P&WC S.B. No. 41110R2

PT6C-72-41110

TURBOSHAFT ENGINE

PERMANENT-MAGNETIC-ALTERNATOR GEARSHAFT AND ROLLER BEARINGS -REPLACEMENT OF

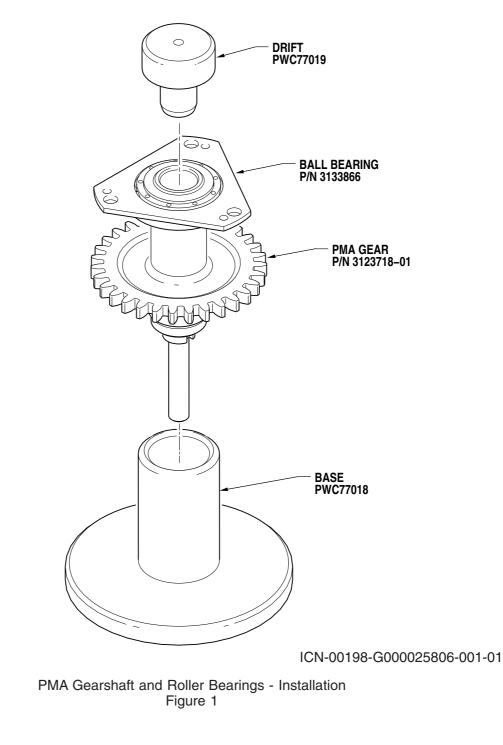
- B. Install the parts in the New P/N list in Para. 2.C., Material Information, in accordance with the overhaul manual instructions and differences that follows (Ref. Table 1, Figure 2 and Figure 3):
  - Ref. OHM 72-60-00 ACCESSORY GEARBOX SUB-ASSEMBLY.
  - (1) Install the PMA gearshaft on base (PWC77018) Ref. Fig. 1.
  - (2) Put the bearing in the oven at  $350^{\circ}$  F (176° C), for 30 minutes minimum.

(3) Install bearing on gearshaft using drift (PWC77019).

NOTE: To remove the bearing please use puller (PWC77020).

- (4) Do an inspection for a proper seating of the bearing, 0.001 in. feeler gauge must not go in.
- (5) If necessary, heat bore with a heat gun (PWC90000) at bearing location for (5) minutes aprox. In a circular motion while maintaining a minimum of one inch clearance between part(s) and heater outlet.
- (6) Install the bearing, mounted on the PMA gearshaft, on diaphragm. Secure with a triple key washer P/N 3115926-01.
- (7) Install three bolts MS9489-08 and torque 36 to 40 Lbf.in. (4.0-4.5 Nm).
- C. Write the accomplishment of P&WC S.B. No. 41110 in the engine module log book.

PMA Gearshaft and Roller Bearings - Replacement of Figure 2

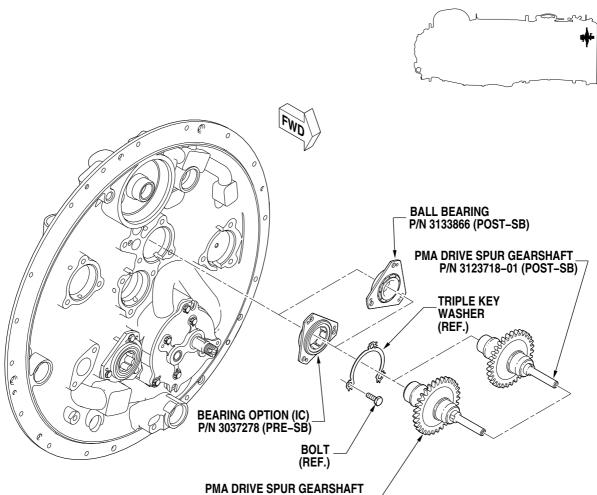
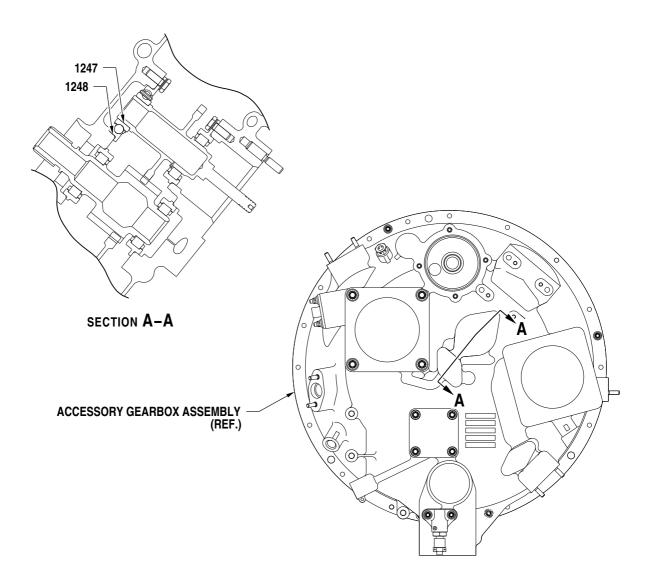
Replace the PMA Spur Gearshaft with a new one and a roller bearing with a ceramic ball bearing.
